Addendum 2

Meinig Park Improvements

BID SET	
REVISIONS	
SCALE	AS NOTED
DRAWN BY	CB
DATE	04.21.2026
PROJECT NO.	2517
GRADING PLAN - NORTH	
L3.01

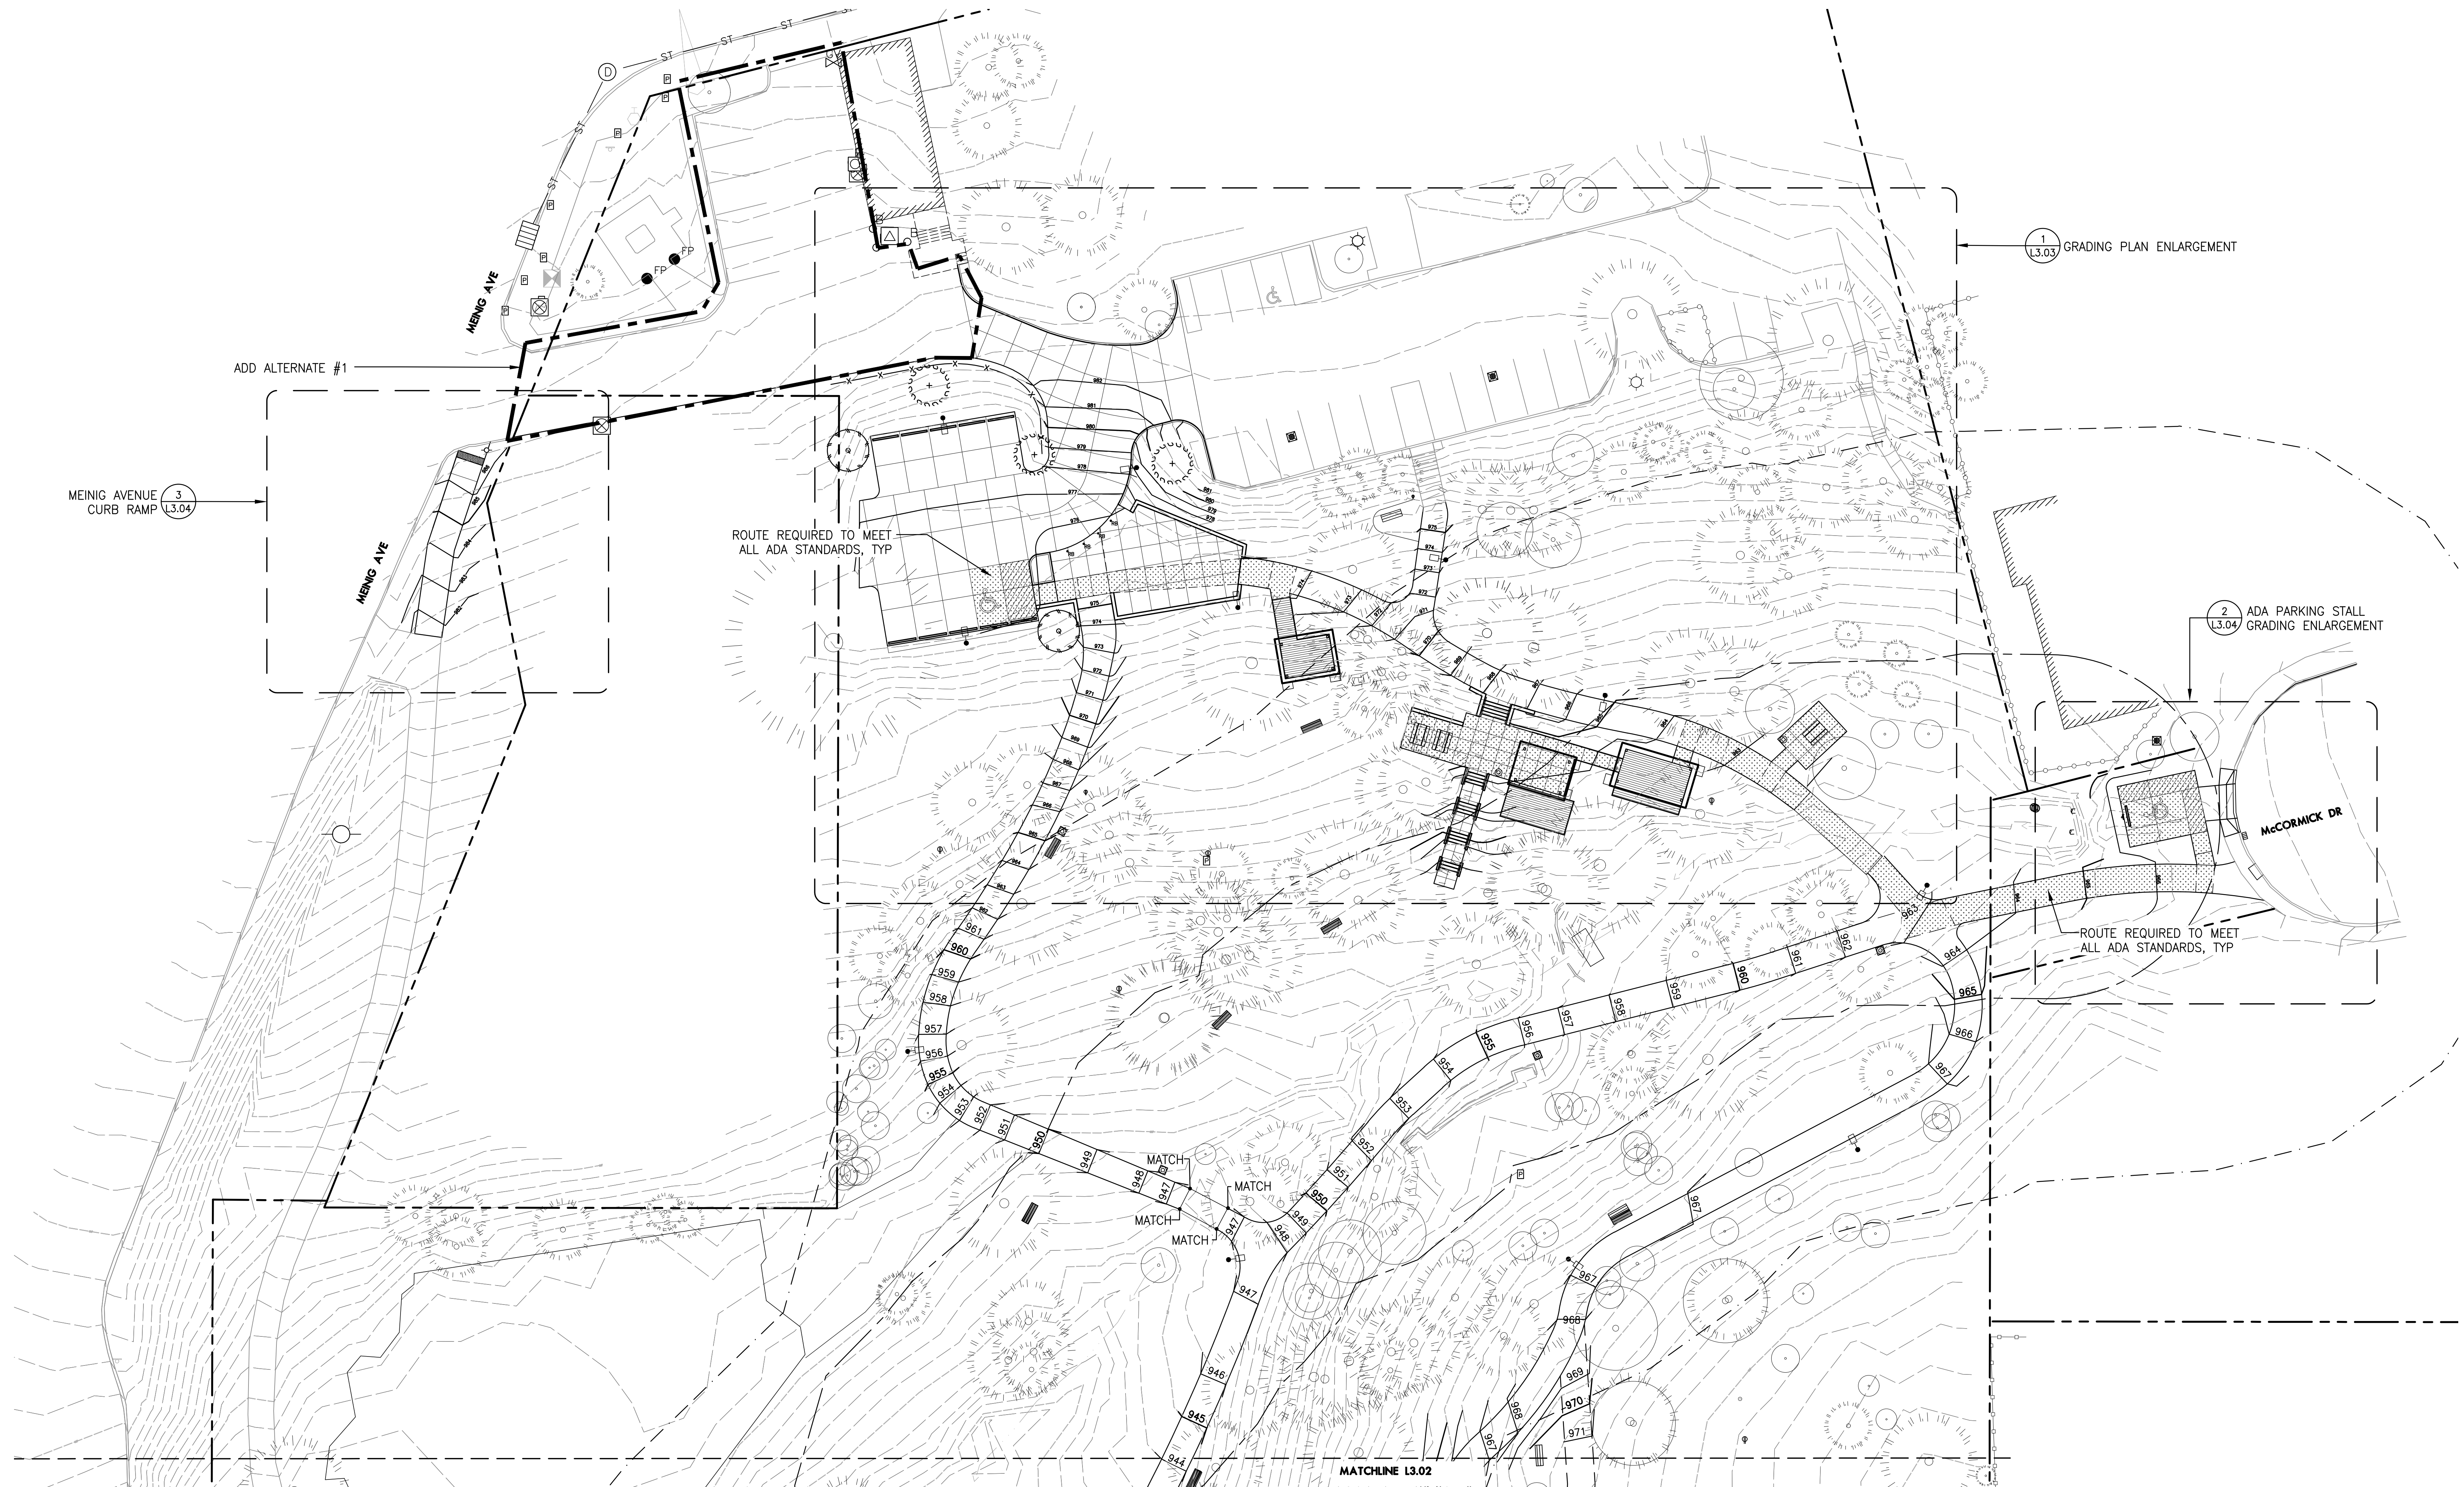
Q1: Is L3.01 also missing? We are hearing from the landscapers that L3.02 appears to be in the plan set twice

A1: You are correct, L3.02 was a duplicate. See attachment on Page 2 for the missing L3.01.
